## HISTORIC AND DESIGN REVIEW COMMISSION

**HDRC CASE NO:** 2018-278  
**ADDRESS:** 1024 BURNET ST  
**LEGAL DESCRIPTION:** NCB 1660 BLK H LOT E 16.2 FT OF N 120 FT OF 6 & W 39 FT OF N 120 FT OF 7  
**ZONING:** R-6, H  
**CITY COUNCIL DIST.:** 2  
**DISTRICT:** Dignowity Hill Historic District  
**APPLICANT:** Trinie Hellmann  
**OWNER:** Trinie Hellmann  
**TYPE OF WORK:** Carport construction  
**APPLICATION RECEIVED:** May 22, 2018  
**60-DAY REVIEW:** July 21, 2018  
**REQUEST:**

The applicant is requesting a Certificate of Appropriateness for approval to remove an existing, attached carport and construct a new one in the same location.

**PLOT PLAN**  
FOR BUILDING PERMITS

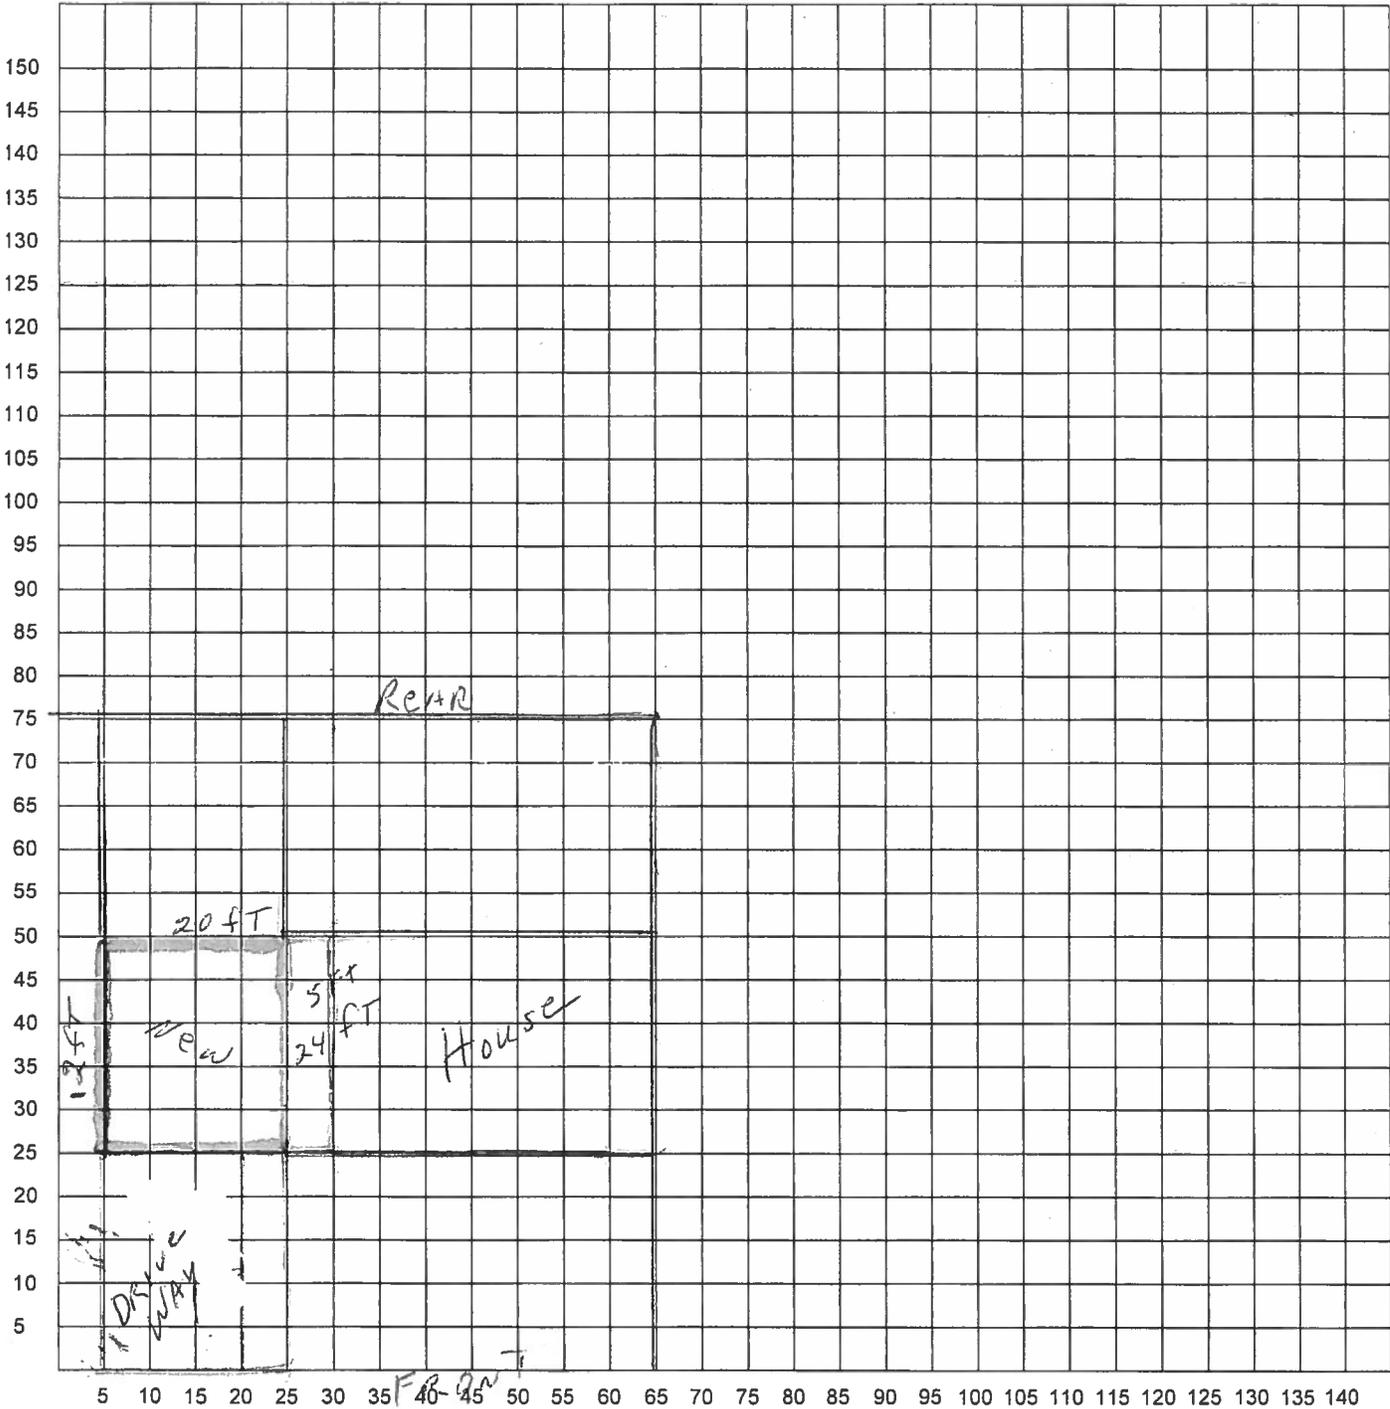
- b. **CARPORTR RECONSTRUCTION** – The applicant had begun reconstruction of the non-conforming carport prior to approval. The previous carport had been installed since at least 2003 without approval or permits and featured a dimension of 20ft wide by 24ft deep of wood construction, a sloped shingle roof from 9ft to 14ft, and a metal bargeboard cover. The proposed carport features matching construction and dimensions excluding the metal bargeboard cover. Staff finds that the proposed carport is generally appropriate considering the wood construction and shingle roof matches the primary historic structure. However, per the Guidelines for Garages and Outbuildings 5.B.i, garages attached to the primary structure should not be introduced on blocks where they are not historically found. Staff finds that a detached carport is more appropriate.

- i. The new carport features a width, height, and depth no larger than the previous carport.
- ii. The new carport features wood construction and a shingle roof without metal cladding.
- iii. The new carport be detached from the primary historic structure; additional wood columns may be installed to support a freestanding carport.
